Office Action Summary	Application No. 10/505,253	Applicant(s) RASA ET AL.	
	Examiner Jason Prone	Art Unit 3724

Claims 35-43, 47, 49, and 51 are rejected under 35 U.S.C. 103(a) as being unpatentable over Neveu (3,961,418) in view of De Vault (2,106,796). Please see Appendix A for examiner added reference numerals to Neveu.

Appendix A

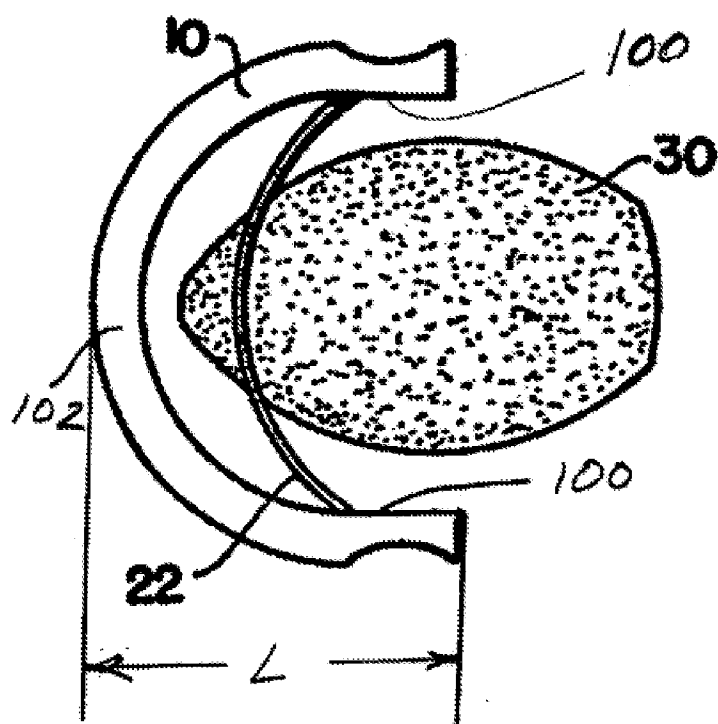
In regards to claim 35, Neveu discloses the same invention including a peeler for peeling in a peeling direction (Title) comprising two lateral gripping surfaces (100) interconnected by a blade (22) and by a cross-piece (102), wherein the two lateral surfaces together with the cross-piece for a substantially U-shaped holder (Fig. 2), and the peeler being shorter in the peeling direction than a distance between the lateral surfaces at the peeling blade (See Appendix B, the Peeling Direction is labeled PD and the dimension of the peeler along line PD is clearly less than the spacing between gripping surfaces 100).

Also, Neveu fails to disclose the distance between the lateral gripping surfaces at the peeling blade is larger than a length and height of the peeler. Looking at Appendix A, it would have been obvious to shrink the “L” dimension to accommodate a hand with shorter fingers. It is old and well known to experiment/try larger and smaller size components since not everybody has the same sized/shaped body parts. It would have been obvious to one having ordinary skill in the art at the time the invention was made to have the distance between the lateral gripping surfaces at the peeling blade be larger than a length and height of the peeler, since it has been held that where the general conditions of a claim are disclosed in the prior art, discovering the optimum or workable ranges involves only routine skill in the art. *In re Aller*, 105 USPQ 233. Also, it would have been an obvious matter of design choice to have the distance between the lateral gripping surfaces at the peeling blade be larger than a length and height of the peeler, since such a modification would have involved a mere change in the size of a component. A change in size is generally recognized as being within the level of ordinary skill in the art. *In re Rose*, 105 USPQ 237 (CCPA 1955). Therefore, it would have been an obvious matter of design choice to modify the device of Neveu to obtain the invention as specified in claim 35. The claim would have been obvious because a person of ordinary skill has good reason to pursue the known options within technical
